**Subject:** Submittal of Replacement Pages to Update the NAC-UMS<sup>®</sup> FSAR from Revision 4 to Revision 5 (Docket No. 72-1015)

**10 CFR 72.48 Evaluation Summary Report**

**NAC-UMS<sup>®</sup> Universal Storage System  
(Docket No. 72-1015)**

PROJECT 790 DRAWING 584 REV 19

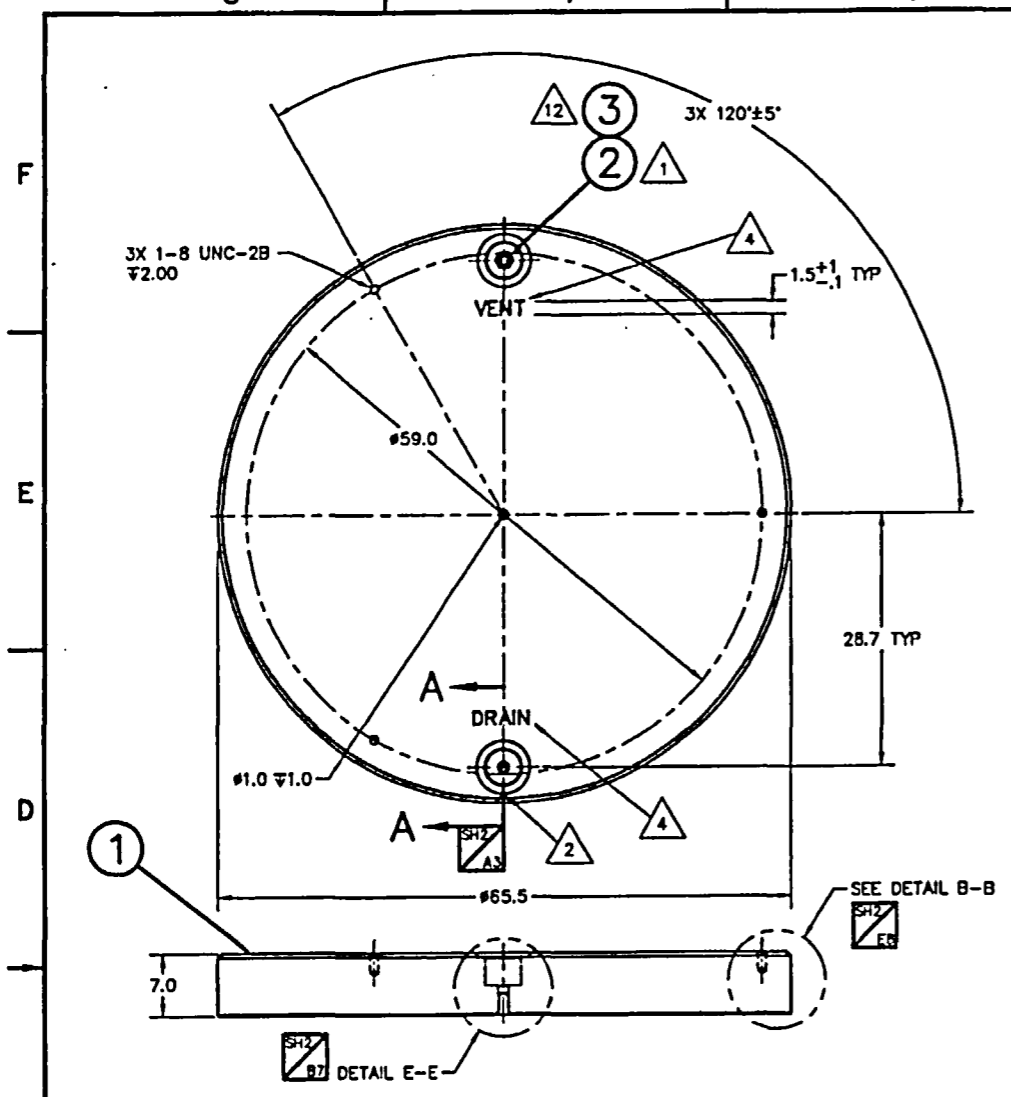
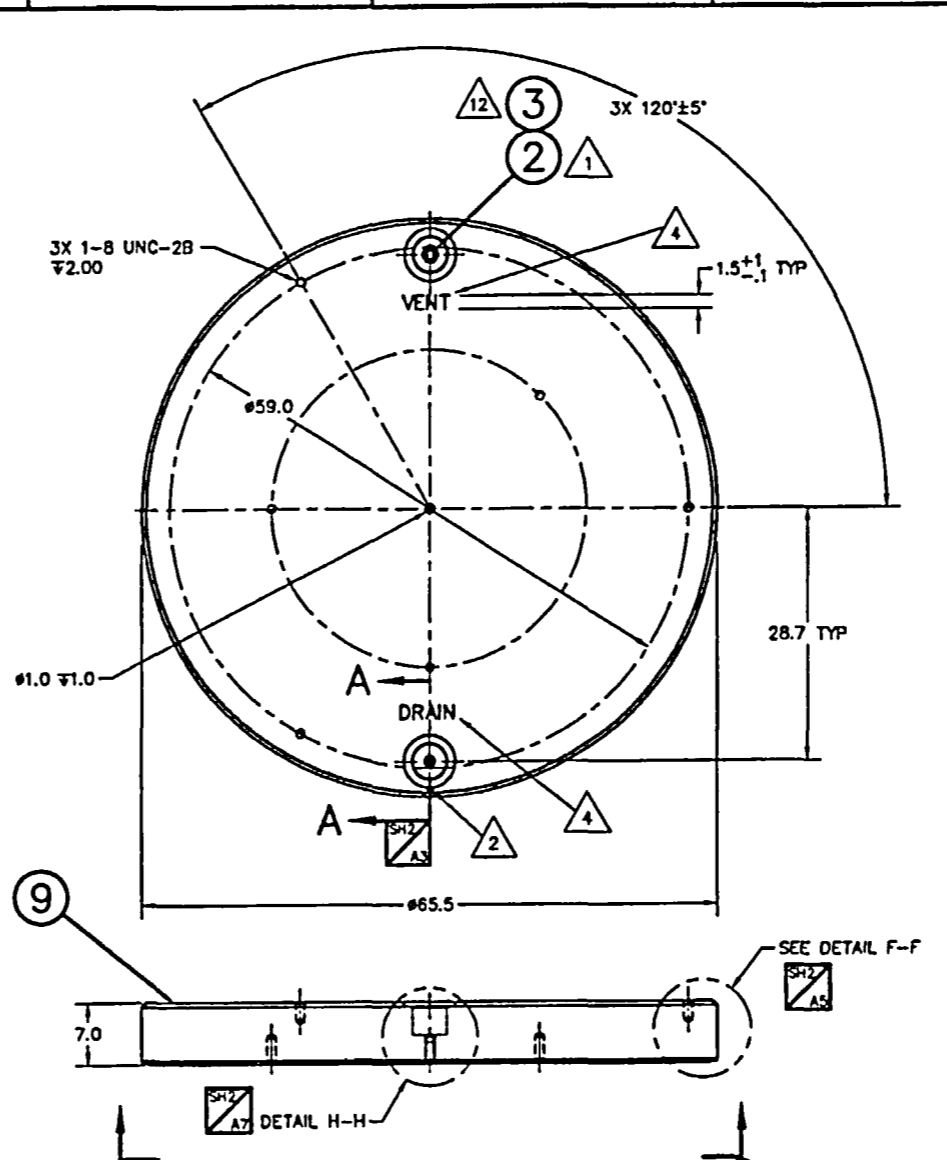
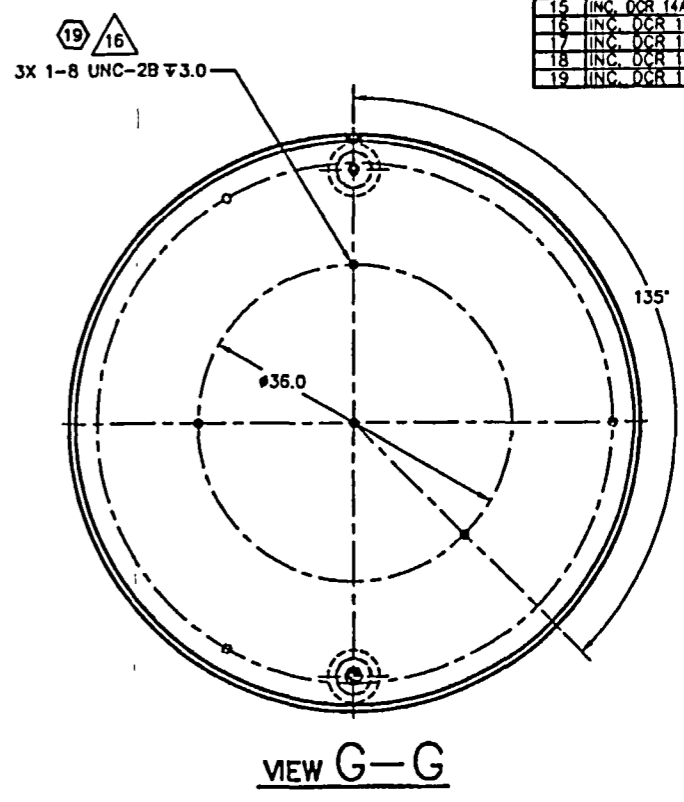
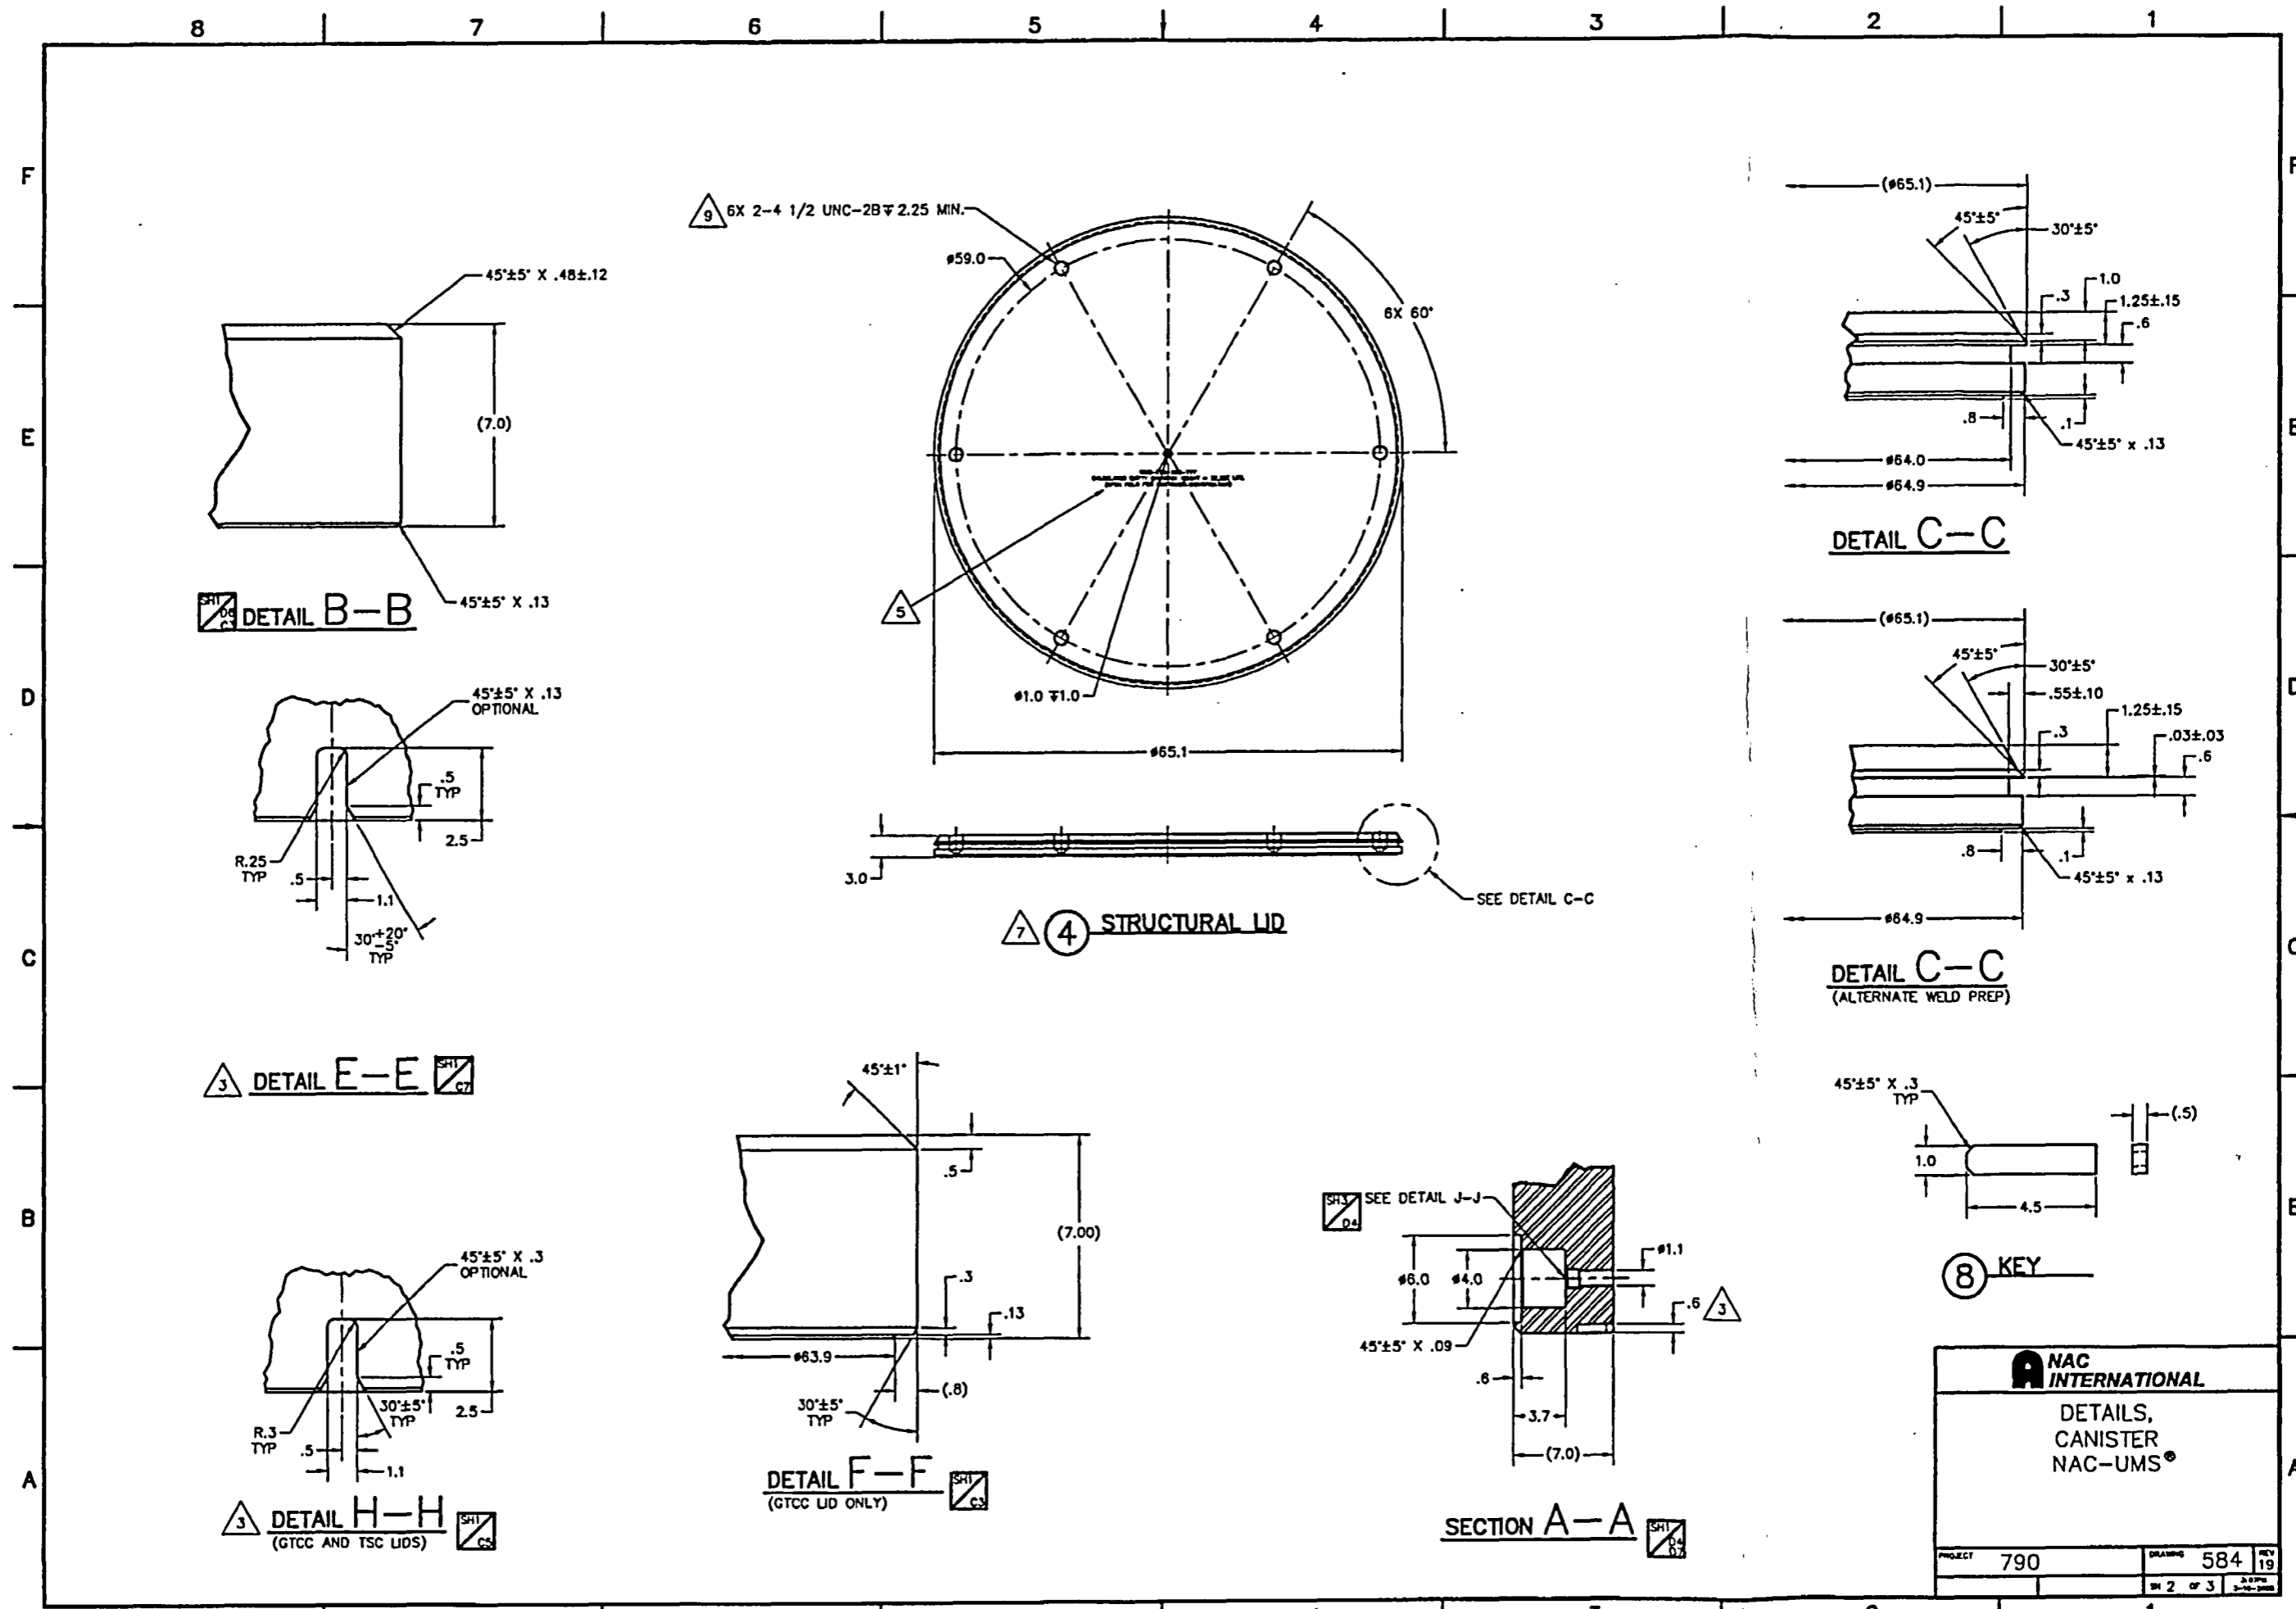
1. Changed Delta Note 5 to read, "...for a particular project code, or other unique identifying number, and the YYY...."
2. Changed all dimension callouts in Detail J-J to be reference dimensions.
3. Added a Delta Note callout to Detail J-J that reads, "Surface finish requirements are optional for detail J-J."
4. Added a Delta Note callout to dimension leader callout (3X 1-8 UNC-2B) Sht 1 of 1, Zone 2E to read, "Alternatively, the location of these three shield cover attachment holes can be matched drilled with the shield cover."
